to: City of Madison Transportation Commission members
re: Agenda #2, Geometry of Mineral Point Rd's widened sidewalk

I encourage the T.C. to ask for these further changes to the Mineral Point Road (MPR) sidewalk geometry:

1. Eliminate four redundant driveways

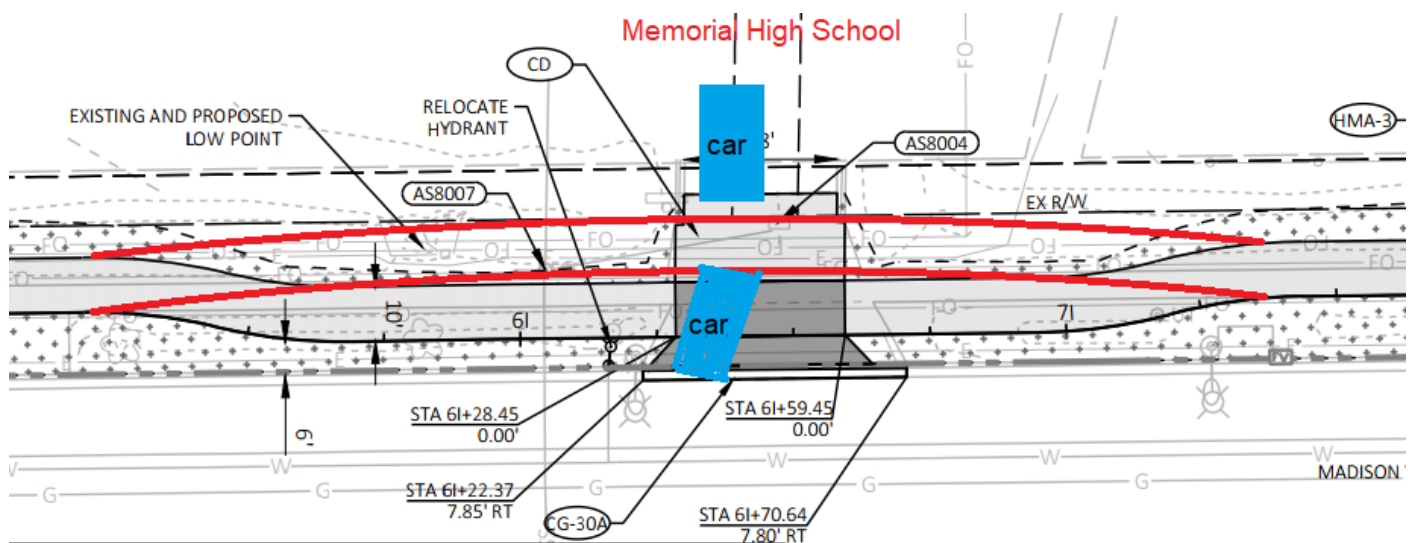
- Kwik Trip (7502-7520) has two MPR driveways. For years, the western one exclusively served the car wash, so it was naturally metered. Since their 2022 reconstruction, it now acts as an overflow for when the other driveway is backed up. Close it.

- The Montessori school (7610) has a calm back entrance on Westward Way. They also installed bicycle parking along where the widened sidewalk will go, a very thoughtful step that suggests they may be open to closing their MPR driveway.

- The Associated Bank (7722) and its MPR driveway were both built in 2020. It was a mistake to allow that driveway to be built since the bank's main entrance on High Point can easily serve the same traffic. Their driveway should be closed.

- The Oakbridge Commons strip mall (7874) is very well served from High Point Rd and Tree Lane. Its middle MPR driveway should be closed. The freed-up space can be used to add between 14 and 30 more parking spaces.

Removing these will greatly improve safety of the section from Randolph / Kwik-Trip to the beltline. That 1/2 mile section is heavily used, and already has more bike/ped crashes than the other 2+ miles of MPR.

3. Remove two short, tight jogs

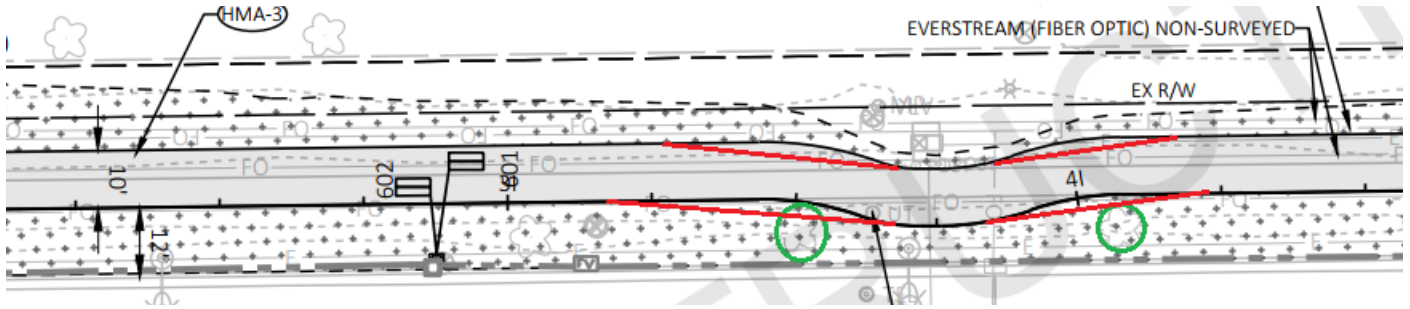
One jog is on the western side of Mansfield athletic fields by Memorial H.S. It's 50' long, which is approximately 2¼ seconds for a bicyclist. It will feel unnatural and be a pinch spot given the proximity to trees, an electrical box, and a light pole. It should be stretched out to 100' (similar to the culvert jog to the east). That will require removing one or both trees circled in green.

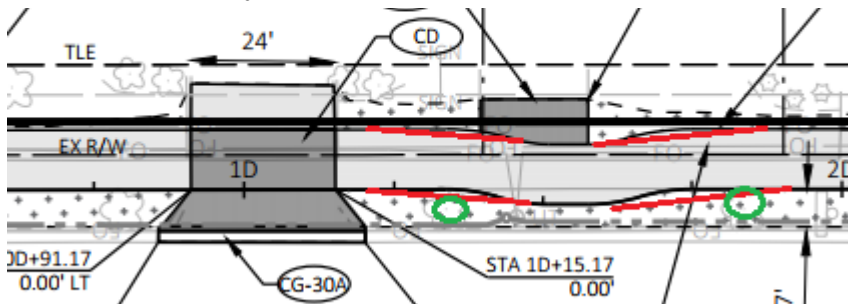
There's a similar short jog near the Montessori School's bike parking east of Westward Way that should also be stretched out. Again, one or both trees circled in green will need to go. This will be easier if the redundant driveway is also removed.

5. Eliminate the 5' sidewalk by Isle of View Apartments, next to Nautilus Park

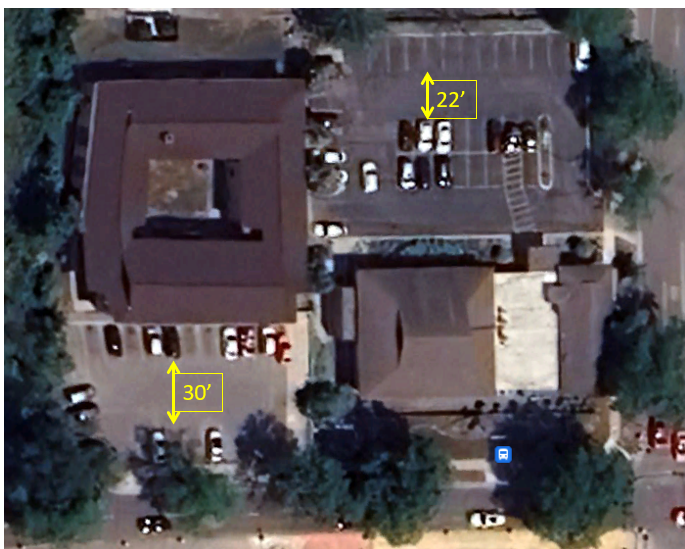
The parking lot's aisle is 30' wide. Google tells me such aisles are 14 to 24', and the neighboring apartment's aisle is 22'. Shrinking that parking lot by 6' would create space for an 8-10' widened sidewalk. It will result in the loss of at most one parking spot and require moving some electrical utility boxes. This seems like a no-brainer, especially with the City's optimism to eventually widen the path by Nautilus park.

6. Grand Canyon Drive NB markings

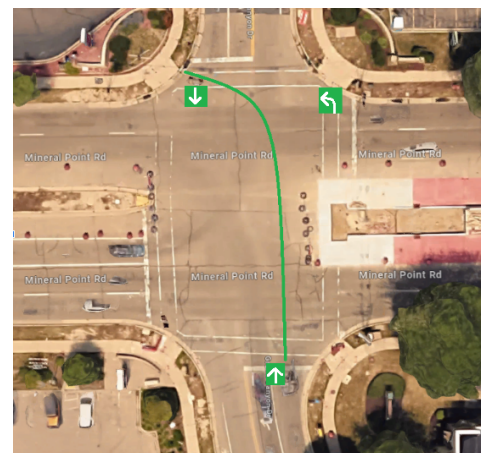
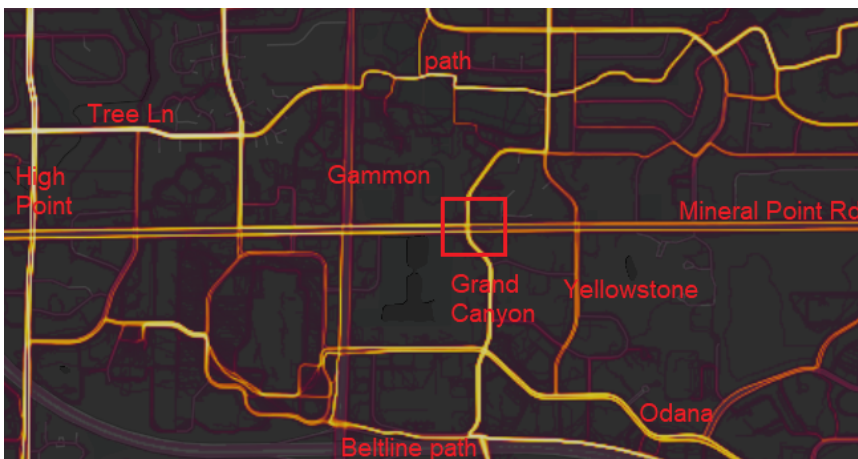
Grand Canyon Dr is one of the area's most heavily-biked roads, as shown in the Strava heatmap. Please consider lane/paint changes to help NB bicyclists turn left onto the new widened sidewalk. E.g., a left turn lane, a two-stage turn box, a lane lines, etc.
